NIAGARA MOHAWK POWER CORPORATION

LICENSE NO. DPR-63

DOCKET NO. 50-220

Supporting Information and No Significant Hazards Consideration Analysis

FIGURE 2.1.1
FLOW BIASED SCRAM AND APRM ROD BLOCK

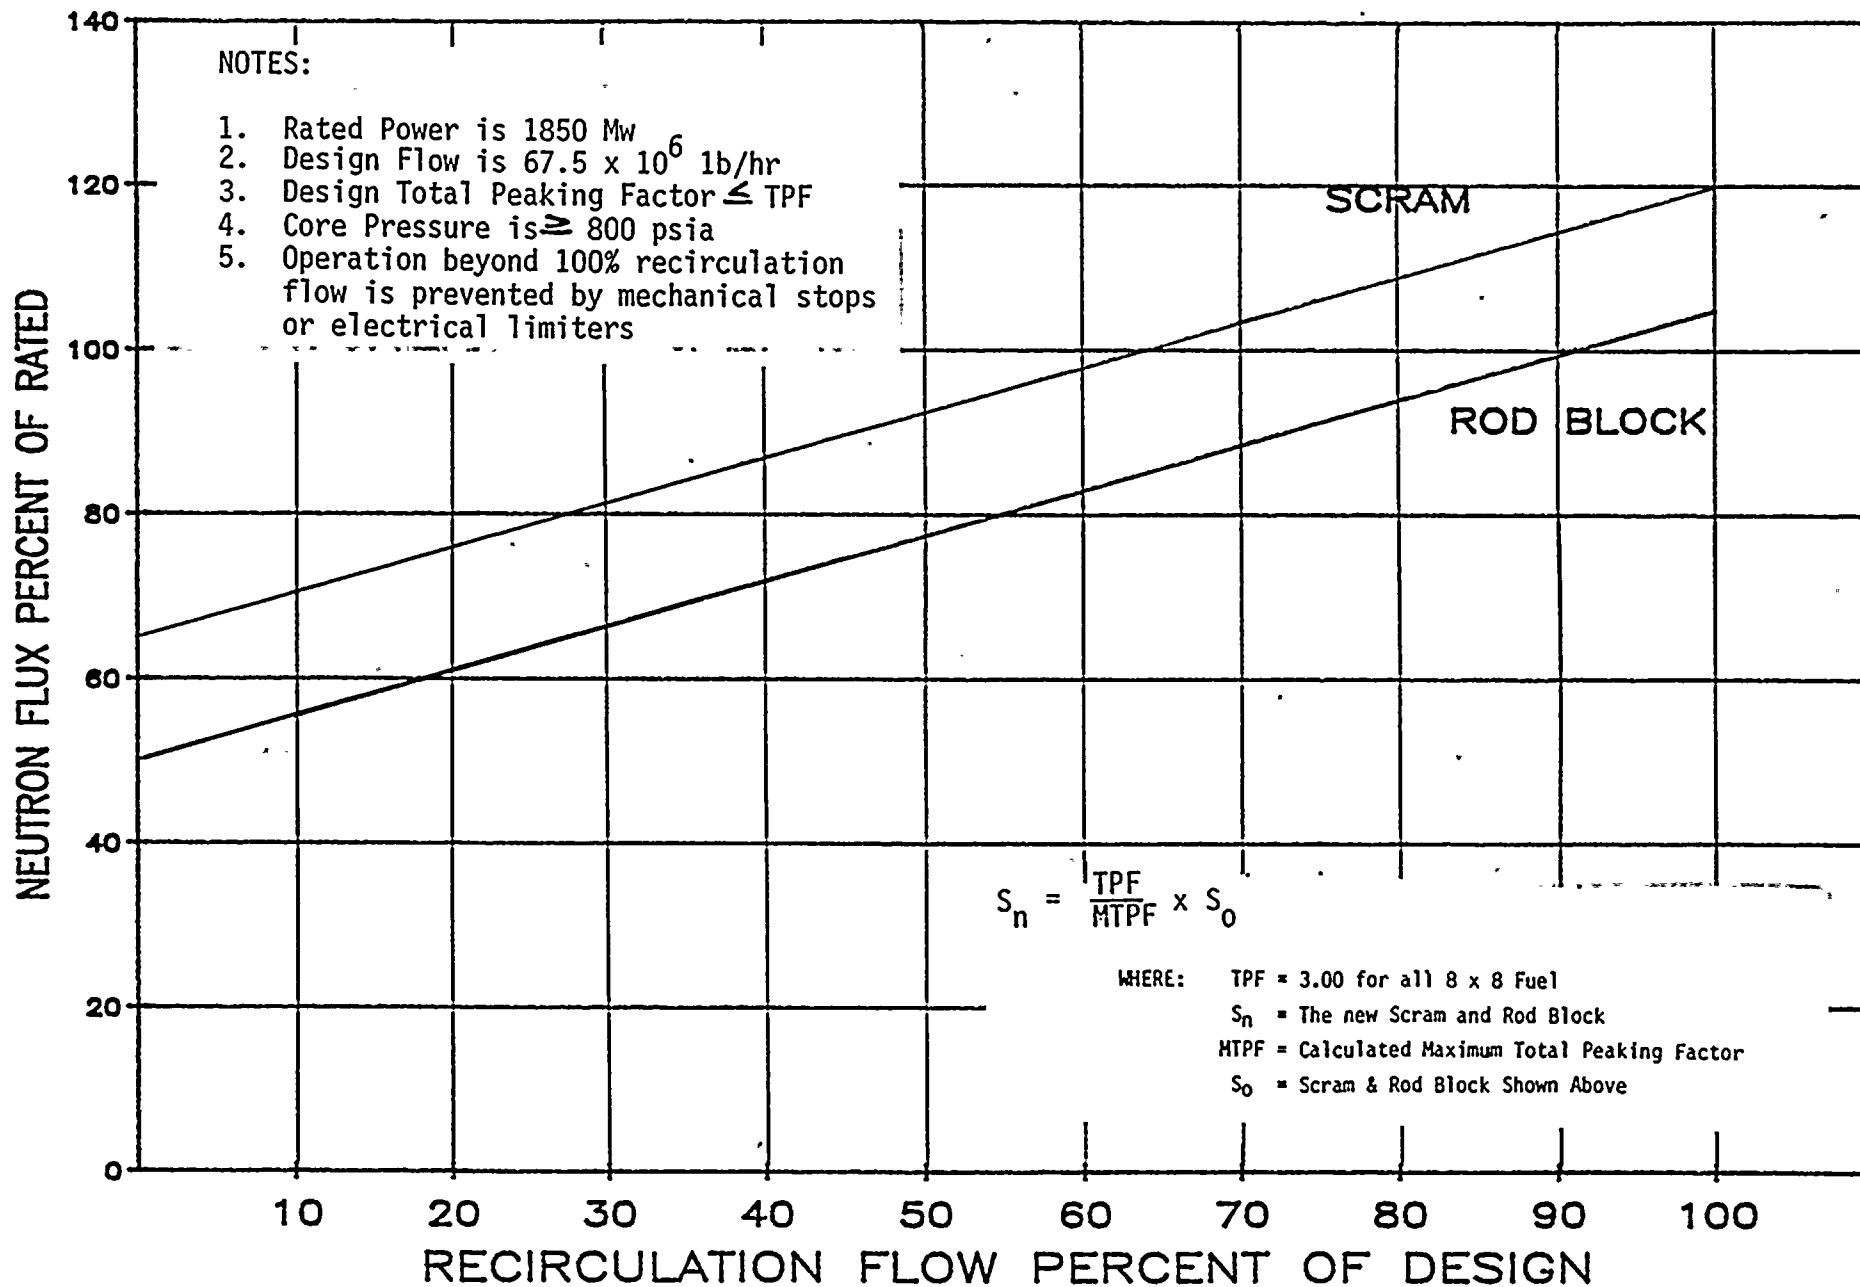
However, in response to expressed beliefs (7) that variation of APRM flux scram with recirculation flow is a prudent measure to assure safe plant operation during the design confirmation phase of plant operation, the scram setting will be varied with recirculation flow. Mechanical stops or electrical limiters are installed on the recirculation controls to prevent operation beyond 100% recirculation flow conditions. The electrical limiter is utilized during end of cycle coastdown conditions. Administrative controls are used to assure that the electrical limiter is adjusted to limit recirculation flow to less than design rated flow (67.5×10^6 lb/hr) with tolerances of plus or minus 1%.

The proposed Technical Specification amendment revises Figure 2.1.1 regarding the limiting relationships between core flow and core power. The proposed revision provides clarification that operation above 100% core flow is not permitted. Mechanical stops or electrical limiters enforce compliance with this requirement. Technical Specification Section 3.6.2, Tables 3.6.2a and g, and Tables 4.6.2a and g are revised to provide consistency with Figure 2.1.1 and to provide a surveillance requirement for calibration of the mechanical stops and electrical limiters once each major refueling outage. During end of cycle coastdown operation, when core flow tends to increase slightly due to changes in core differential pressure resulting from the power decrease, administrative controls are applied to reset the electrical limiter, thus ensuring that the design core flow (67.5×10^6 lbs/hr) is not exceeded. A one percent (1%) tolerance is permitted to allow for inaccuracies in the instrumentation.
